Customer Service Bulletin
Commercial Business Group

Greensmaster® 3200 and 3200-D

Model/Serial Range:	Model Number:	Serial Numbers:
	04380/04381	50001-69999

Subject: Valve available to vary cutting unit drop rate.

Installation Diagrams

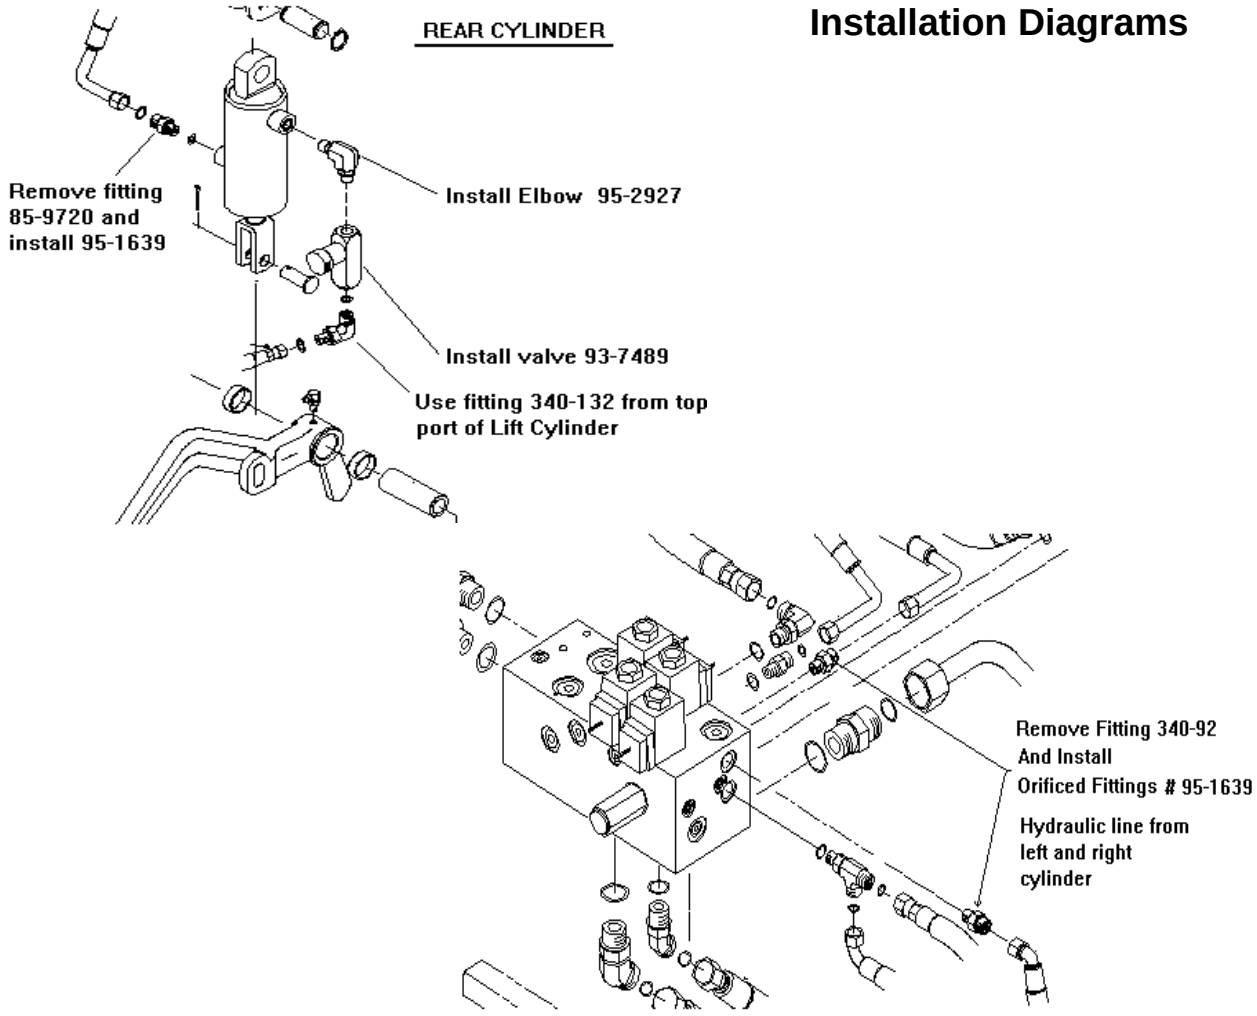
The units in the model and serial number range listed above have a fixed drop rate of the center cutting unit. If the ability to vary the drop rate of the center cutting unit is a desired feature, your unit can easily be upgraded to include the parts needed to provide this ability.

Parts required are:
(1 required) 93-7489 Flow Control Valve
(1 required) 95-2927 Hydraulic 90^0 Fitting
(3 required) 95-1639 Orifice Fitting
